Subject: Vermont Yankee Nuclear Power Station
License No. DPR-28 (Docket No. 50-271)
Vermont Yankee Emergency Plan Implementing Procedure Changes

To: E-Plan Implementing Procedure Controlled Set Holders
From: Technical Support - DCC - Angela M. Hogan
Date: 08/20/2003
Re: Entergy Vermont Yankee Emergency Plan Implementing Procedure Change 219,
Instruction Sheet

A. Procedure No.: OP 3504	Current Revision #: 36	Title: Emergency Communications
B. Description of Change: <ul style="list-style-type: none"> Added description of new PARD circuit. • Fig 5 - updated phone arrangement in RP offices Added description of telephone headsets. Added 2 fax machines and moved VT State Liaison on Figure 6 Removed the NAS phone numbers in App A and Figure 9 Updated phone numbers in App B

EMERGENCY COMMUNICATIONS

Figure 9
OP 3504 Rev. 36
Page 1 of 1
LPC #2

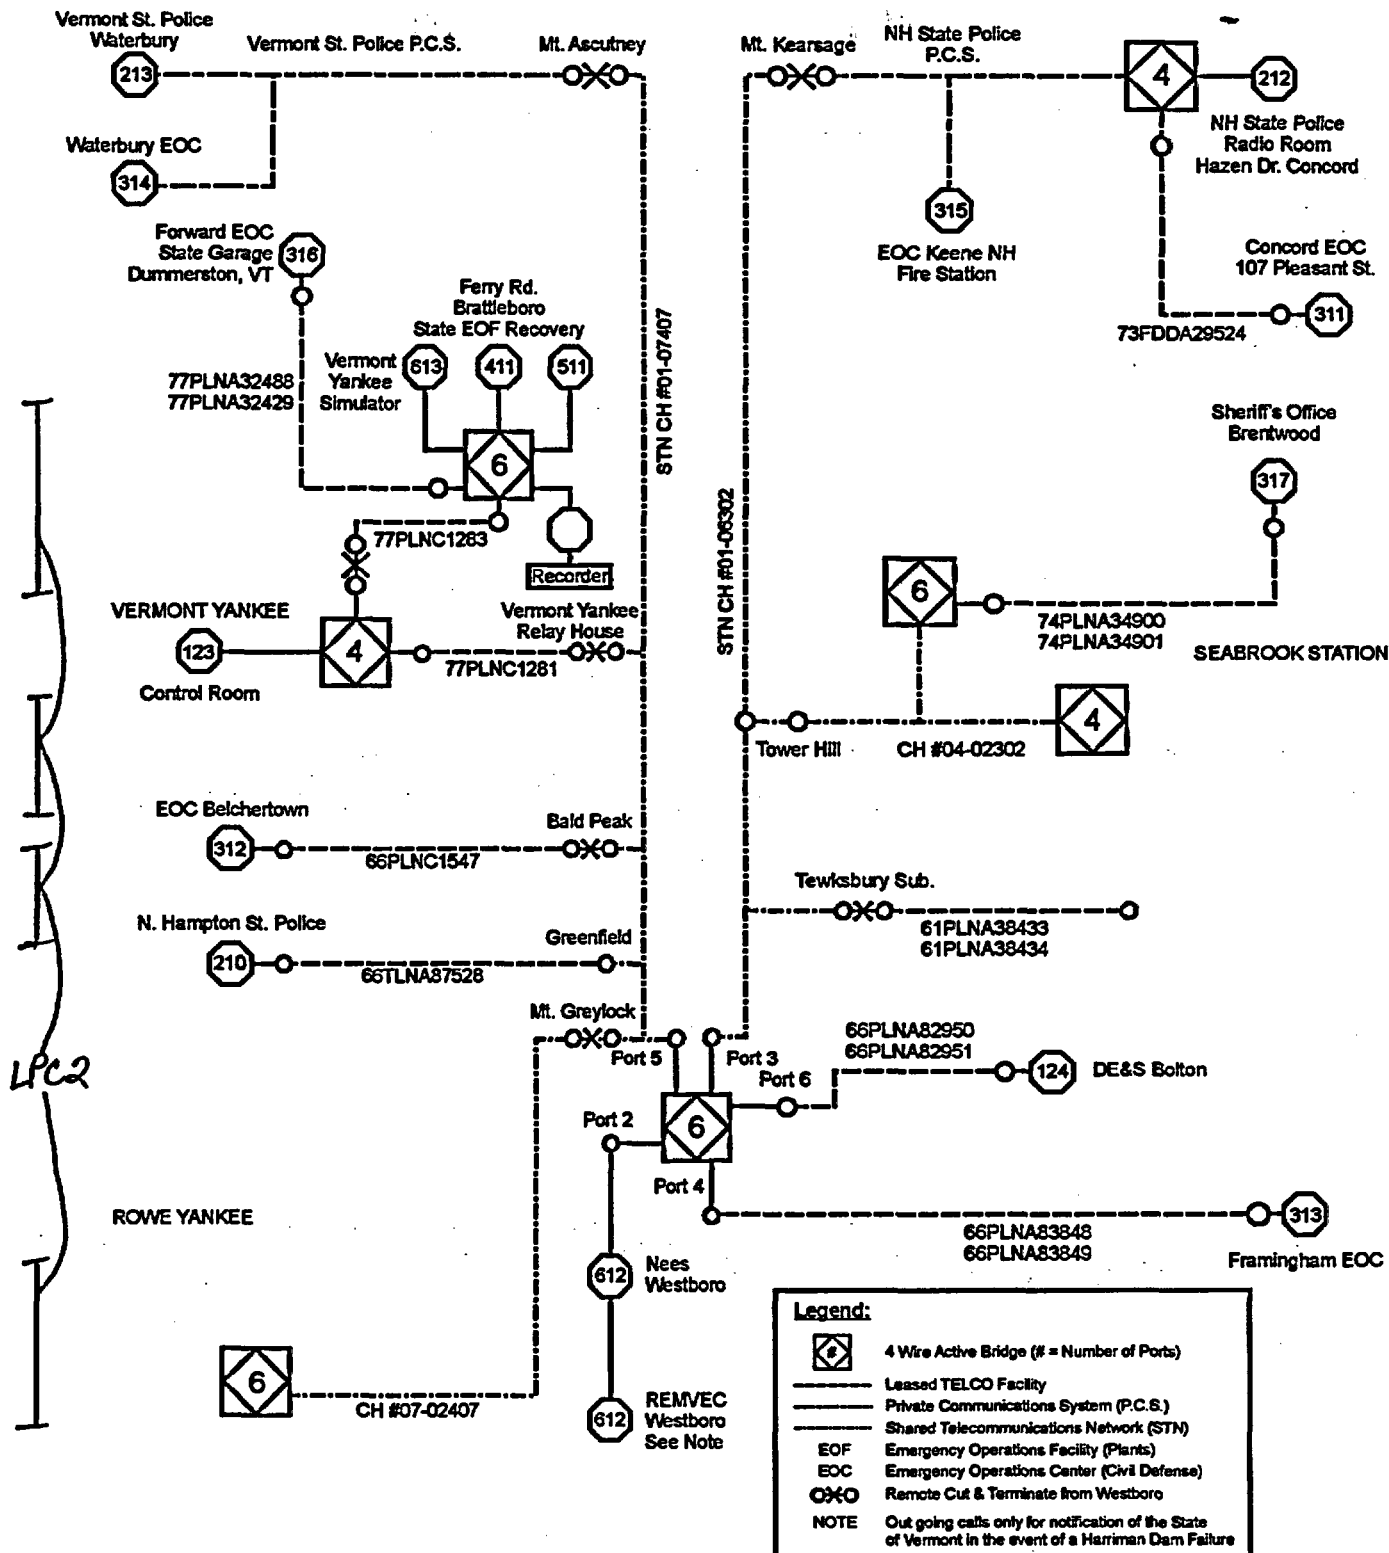
NAS stations removed from service by Yankee Rowe and Seabrook. None of the stations used by Vermont Yankee were removed.
